**Re: APP/25/00744 At Land West of Coldharbour Farm Road, Emsworth,
PO10 7XA**

**Variation of Condition 2 and Condition 17 of planning permission
APP/19/01226 to regularise minor adjustments required by the S278
Technical Approval Process.**

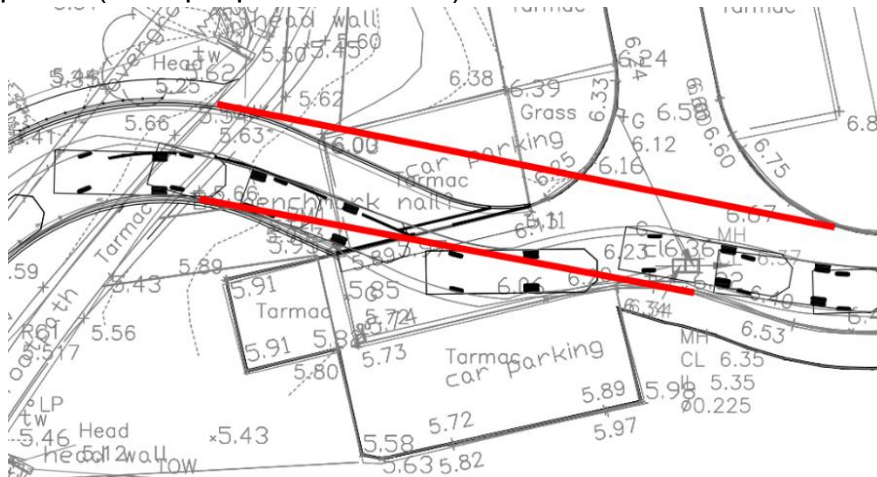
The Highway Authority note that all the tracking presented does not show the s278/built layout, with the kerbing and footway across the parking area, and appear to show a different alignment. The tracking utilises a ‘give-way’ arrangement and does not consider the alterations to the existing cycle route. Most the tracks appear to use this area designated as footway to undertake movements, which is a highway safety issue and would be wholly unacceptable (example provided below):
